APPROVED
MINUTES OF THE MEETING

October 1, 2009

October 1, 2009	Project:	Fire Station 9 - Fremont
	Phase:	Concept Design
	Last Reviewed:	N/A
	Presenters:	Teresa Rodriguez, Fleets and Facilities Department Casey Huang, Mithun Doug Leigh, Mithun
	Attendees:	Christina Faine, FFD Craig Skipton, Mithun David Kunselman, FFD Dove Alberg, FFD Evanne Vaivadas, FFD Jason Huff, Office of Arts and Cultural Affairs Lindsay King, DPD Molly Douce, Fire Department Peter Reiquam, New Art Projects Company

Site Plan

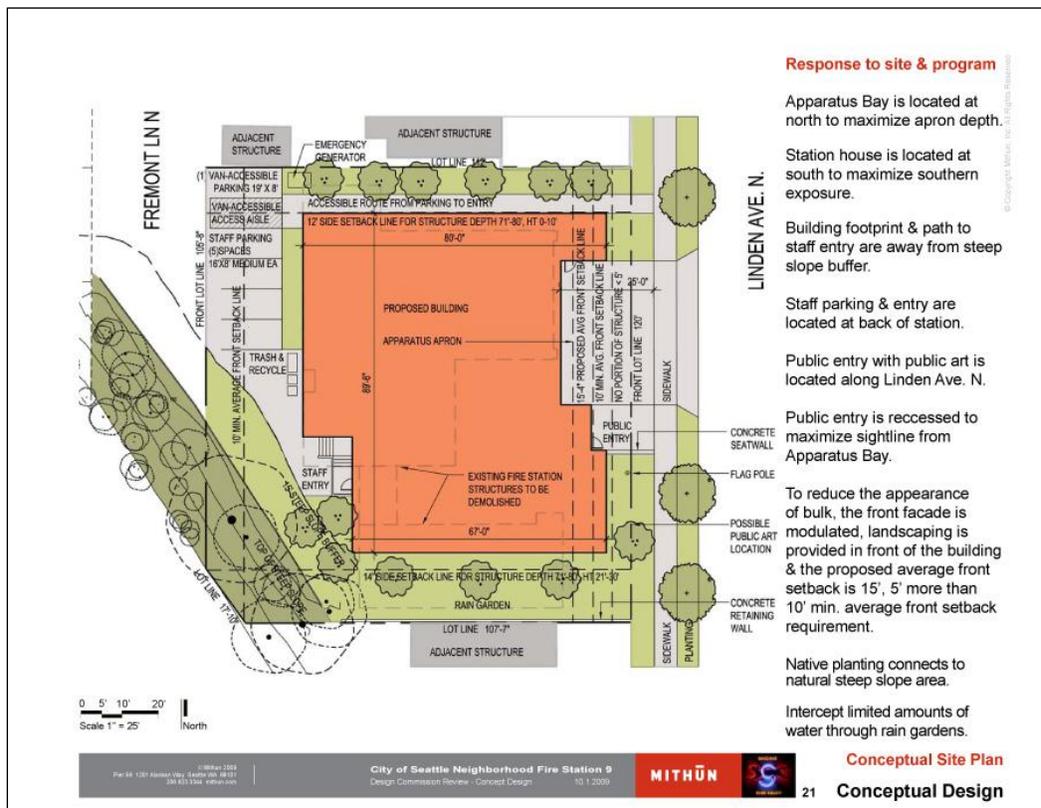
It is a really tight site. Did you try to swap out the site for another?

You might save the annex façade as a freestanding wall. That corner could become really interesting.

Think about a fire station with a porch. Where is the public face component?

Where is trash and recycling? Will it affect car access?

Consider the residents who are on the south in the design of the deck.

What about the edge between the buffer and the lot? There are 3 pinch points.

How much native planting will there be?

Your challenge is to work the proportion of the masses. What we've seen with previous fire stations is that the massing just gets fenestration applied. Relax on the rigidity of the massing.

The temptation is to break down the massing to match the houses. But you may have broken it down too much, more than the houses.

Can you include pervious paving?

Who uses the path on the north?

What about art integration? You have an interesting situation because of the existing art.

We would encourage a freer expression of the art. Don't feel enslaved by the "ever ready" logo.

I encourage you to think about how hardscape and softscape are integrated. They can intermingle.

When we see you again, it would be nice to see the materials.

Yes. Looked but the issue came down to response time and its close proximity to Aurora. The site is not small, but is constricted due to the lowrise zoning.

We studied it. It's in the wrong location. We couldn't fit the whole building program.

It's at the entry. There will be an opportunity with the grade change at the entry for seating walls and other opportunities.

Recycling occurs from the front. The firefighters roll the containers out to the curb.

We may use a solid wall rather than an open railing.

The design is just conceptual right now. We will study it more. We want to minimize the impervious area.

All the way around. A lot is required by LEED Silver. We want to tie it into the steep slope.

We're looking at it. We need to resolve the alley issue. Maybe the staff parking area and the public entrance could be pervious. We're limited by program, but we're looking.

It's an both an accessible route and for hauling garbage.

We haven't gotten that far yet. The "ever ready" logo is a jumping off point.

I don't feel enslaved. I feel inspired by it.
